Access Compliance Report

Public Rights-of-Way

| Intersection ID: 3137 | Main Street: ALAMEDA_LN | Cross Street: STONE_PARK_DR | Location: NW |
| ADA ID: F4305CA0EF0B | Ramp Type: PerpDiag | Initial Pass/Fail: Fail | Overall Compliance: No |

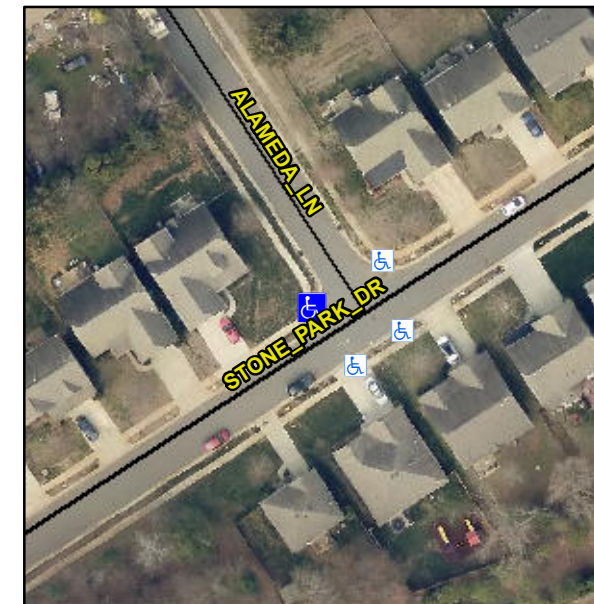
Not Found, R304.5.1, R304.2.2, R304.5.3

| Compliance | Description | Data | Compliance | Description | Data |
|------------|-----------------------|------|------------|-----------------------------|------|
| N/A | Ramp Length (in) | 48.5 | No | Ramp Slope (%) | 8.4 |
| No | Ramp Width (in) | 39.0 | No | Ramp XSlope (%) | 3.5 |

Remove & Replace Curb Ramp With Two New Directional Ramps or Equivalent.
